Project 15210.000

**Subject: Response to Illinois Environmental Protection Agency
Letter Dated March 16, 2010
Former Chemetco, Inc. Facility
3754 Chemetco Lane
Hartford, Illinois**

The IEPA and U.S. EPA's comments have been numbered and are restated below in *italics* followed by AMEC's response in regular font. These responses will be incorporated into the revised Demolition Plan then provided to IEPA and U.S. EPA to facilitate their expedited review of the Demolition Plan.

STORM WATER BMPs DURING DEMOLITION Former Chemetco Site 3754 Chemetco Lane Hartford, Illinois

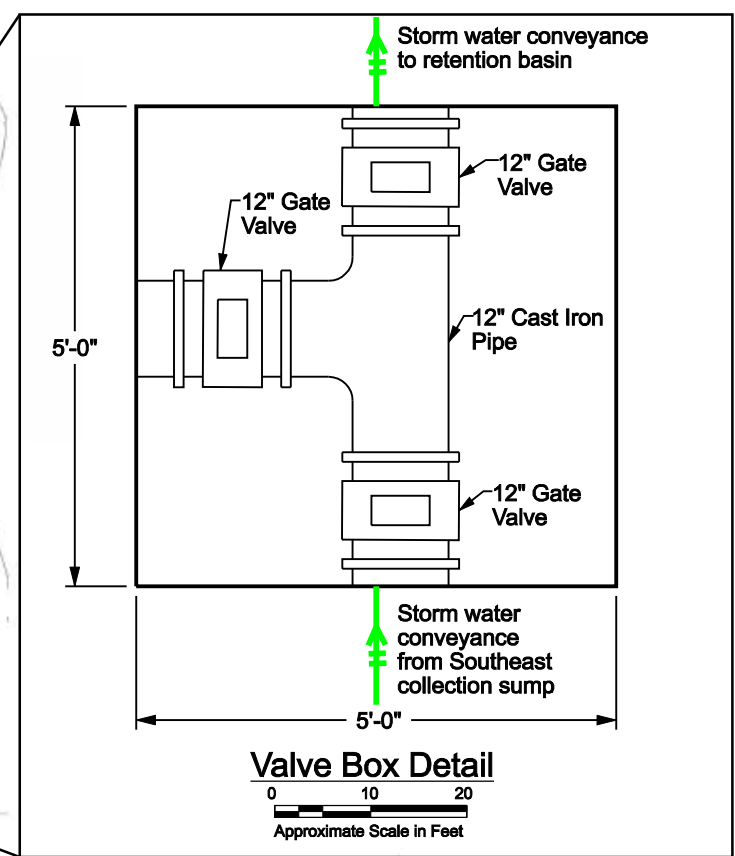
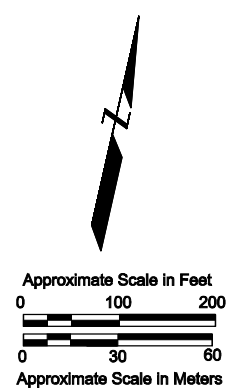
25. *Sections 2.3 and 5.2: The difference between existing and proposed storm water management and control measures appears to be a silt fence along the southern edge of the facility site. Implementation of the proposed stormwater best management practices (BMPs) should be documented in any reports required by Illinois EPA. Discharges from Outfall #5 must comply with the facility's National Pollutant Discharge Elimination System permit.*

AMEC Response: Comment noted. A revised Figure 5 has been attached for your review. This new figure will also be incorporated into the facility Stormwater Pollution Prevention Program (SWPPP) maintained by the Estate. The revised Figure 5 shows the diversion and collection features that will be installed at the Site during demolition. SWPPP measures will be inspected weekly and documented on a form and maintained on file at the Site. As discussed with IEPA, U.S. EPA, and Estate personnel during the Site tour on March 30, 2010, storm water that will collect in the two existing sumps on the south fence line will be diverted through an existing 6-inch above ground PVC pipe that connects to the Retention

Basin. Storm water will then discharge in a controlled manner through Outfall #5 under the existing conditions stated in the National Pollutant Discharge Elimination System permit. IAD will also place cobble-sized limestone aggregate along the banks of the south side of the Retention Basin at the present discharge points for purposes of erosion control and preventative maintenance. Water that may accumulate within the AAF area is presently removed via the Main Pump House and either transferred to the former cooling canals or directed to spray irrigation for purposes of evaporation and volume control. Once demolition starts, spray irrigation for volume control will likely cease and any water removed from the AAF area via the Main Pump House will be conveyed to the existing cooling canals.
